# Wheeler Kearns Architects

Subject: PC #16-014 Round 1 Comments: Variation and Special Use Permit Application at 1234 N Arlington Heights Road

*Our Saviour's Lutheran Church*  
Arlington Heights, Illinois

COLUMBARIUM PHOTOMETRIC STUDY- NORTH FACE ELEVATION  
SCALE 1/2"=1'-0"

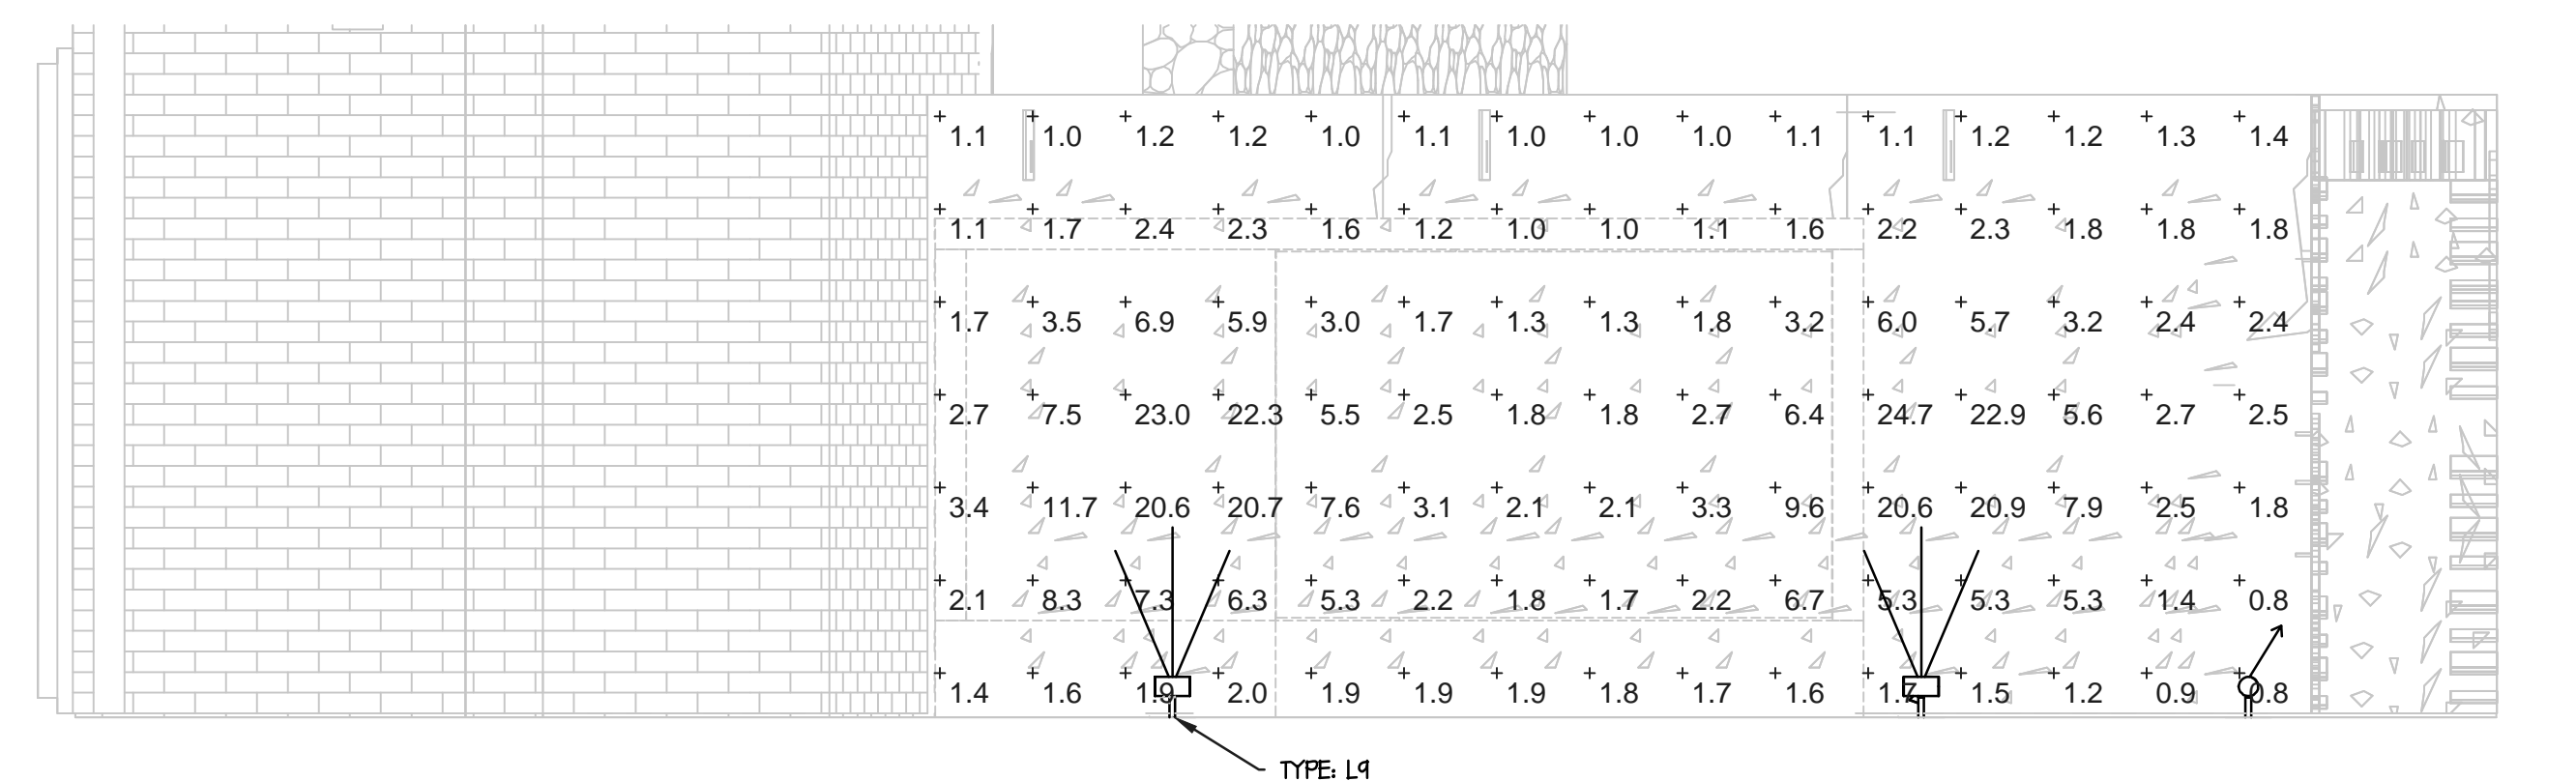
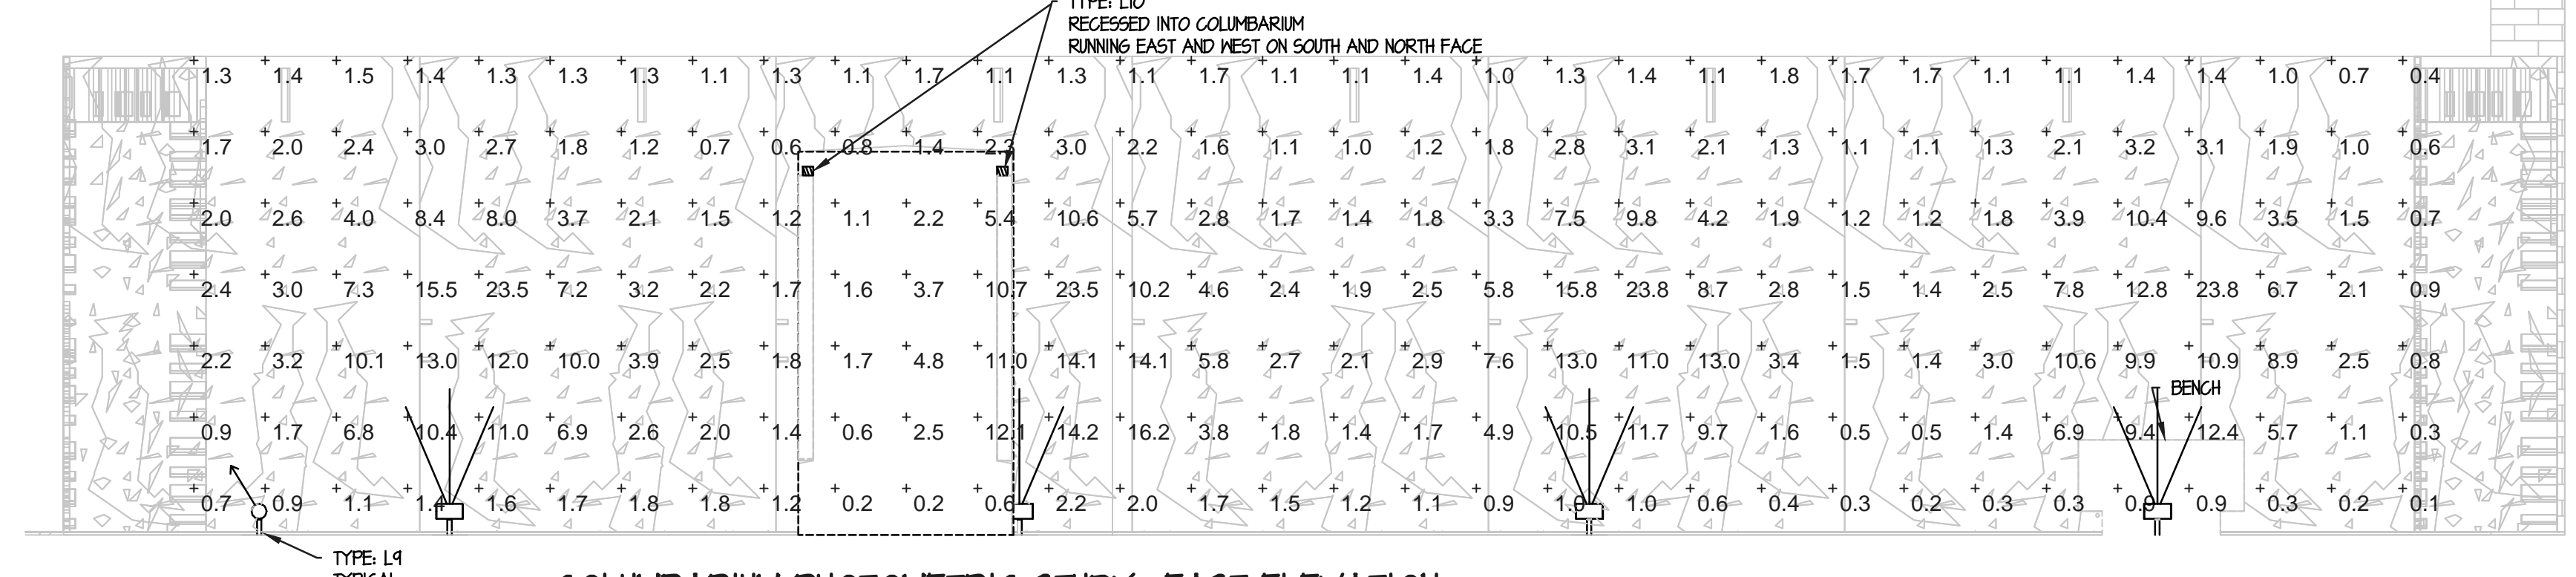
Police Department	2	Are lighting requirements adequate for safety?	Surfaces within proposed Columbarium shall be lit, including inside of landscaping, surfaces of Columbarium itself, ground surrounding bench, and the area underneath the ornamental tree, as well as light spilling from the interior of the building. The design intent is to illuminate faces, but that space is not so bright as to invite attention from the street. An exterior wall mounted motion activated light fixture shall be installed by the exterior entrance to the proposed Columbarium, and a security camera will be focused on the exterior entrance.
	6	(a) Emergency contact information card	Enclosed
